SUBJECT: Transmittal of Revised Responses to AP1000 DSER Open Items

**AP1000 Design Certification Review
Draft Safety Evaluation Report Open Item Non-Proprietary Responses**

DSER Open Item Number: 19.1.10.1-5 (Response Revision 1)

Figure A5.3-25

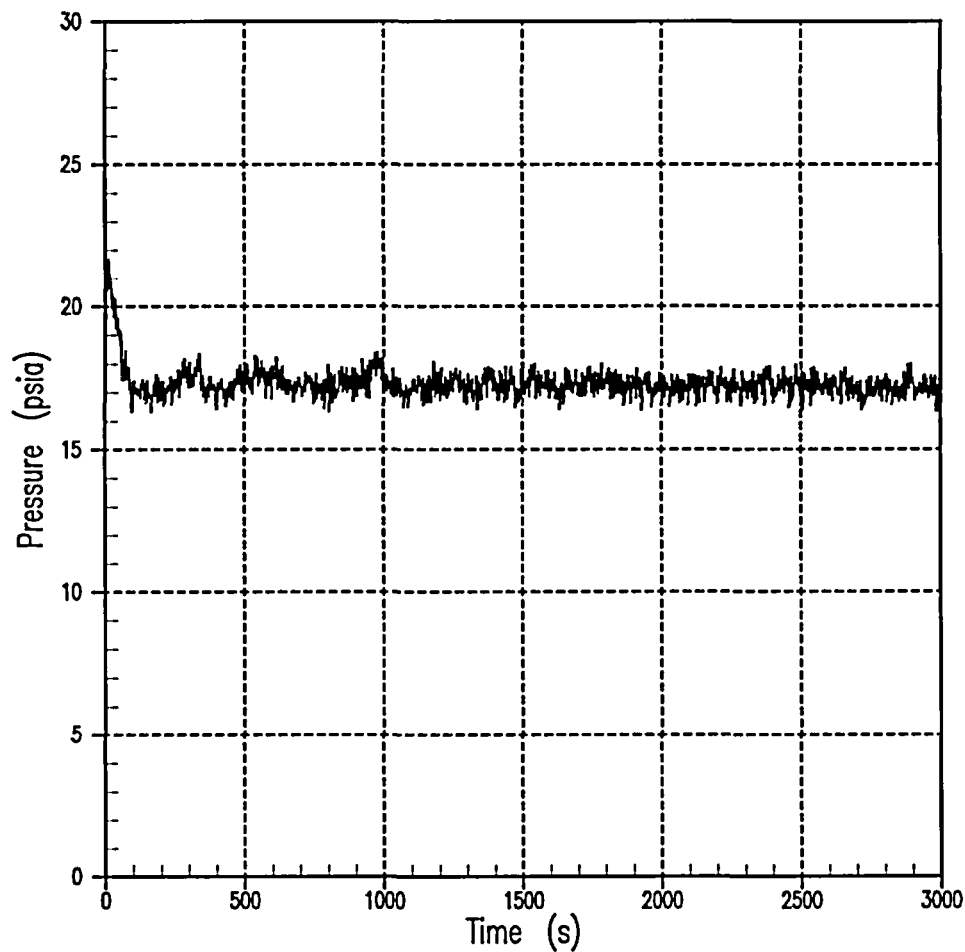
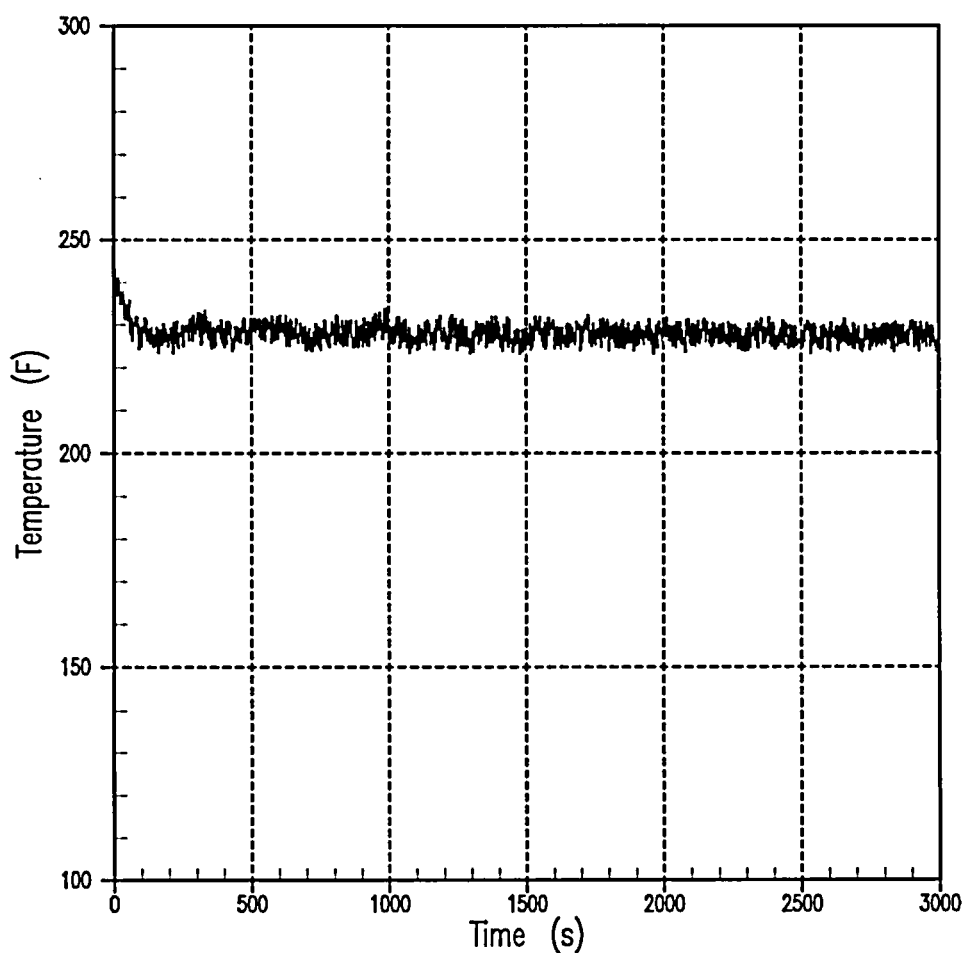
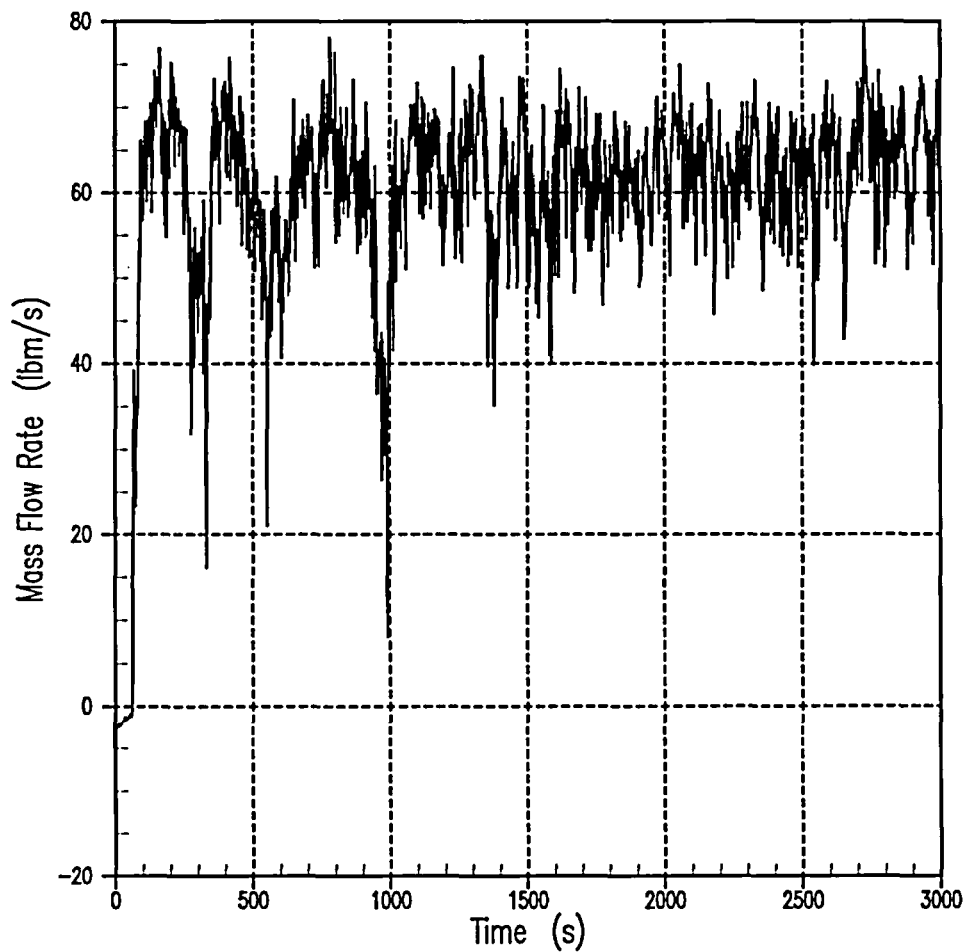
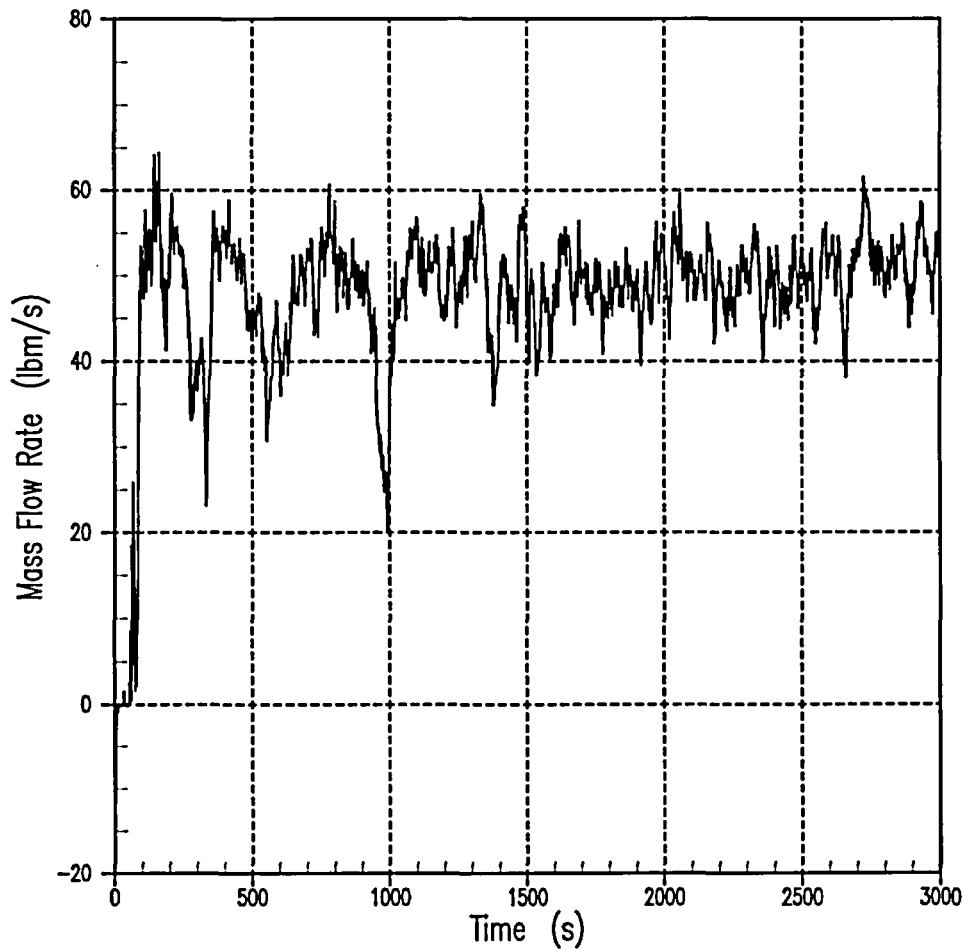
This issue remains open. In the revised response to RAI 720.013, Westinghouse performed long term cooling analyses for bounding conditions in the PRA. (Case F DEDVI, 1 CMT, 1 recirc line, 3/4 ADS4 and CI) and (Case G DEDVI, 1 CMT, 1 recirc line, 4/4 ADS4 and CI failure). The WCOBRA/TRAC code was used for LTC calculations with input conditions derived from MAAP4 analyses. As discussed in the DSER the staff has not reviewed MAAP4 except for its use in screening studies. These are analyses using minimum equipment sets as discussed in the DSER. The staff believes that only a methodology the staff has reviewed should be utilized. In addition, as a result of staff and ACRS questions, the WCOBRA/TRAC long term cooling model has been changed. The staff believes that the revised model should be used in these bounding calculations.

- (a) The long term cooling success criteria analysis case and the thermal hydraulic uncertainty cases F and G have now been performed using the revised WCOBRA/TRAC model and using input conditions from WGOETHIC. The revised cases replace the previous cases as shown below in the revision to PRA Appendix A.

Initially, the only injection comes from the IRWST into the reactor vessel through the intact DVI injection line (Figure A5.3-28). Since at the beginning of the analysis, the level in the PXS-B room is below the DVI injection nozzle elevation, only steam from the downcomer is vented out through the break. Water starts to flow back into the downcomer through the broken DVI line about 2 hours into the transient. This is the time when the level has about reached its minimum value in containment, yet decay heat is still relatively high in the PXS-B room becomes high enough to provide sufficient driving head for this to happen. This time, unlike the Case F DVI break scenario, the transition into reversed injection of water through the break into the downcomer occurs a little earlier, and is somewhat softer. As a result, the increased depressurization rate observed in Case F does not occur. Still, the levels in the downcomer (Figure A5.3-15), the reactor core (Figure A5.3-16) and the upper plenum (Figure A5.3-22) are maintained high enough by the available DVI injection to provide acceptable core cooling.

The availability of all ADS Stage 4 valves provides enough venting capacity to assure adequate depressurization and successful performance of the passive safety systems (Figures A5.3-23 and A5.3-24). The fuel remains covered throughout the transient, and adequate core cooling is provided to remove the decay heat. The hot rod cladding temperature at the top of the core is about 20°F above saturation (Figure A5.3-26) and steadily decreasing.
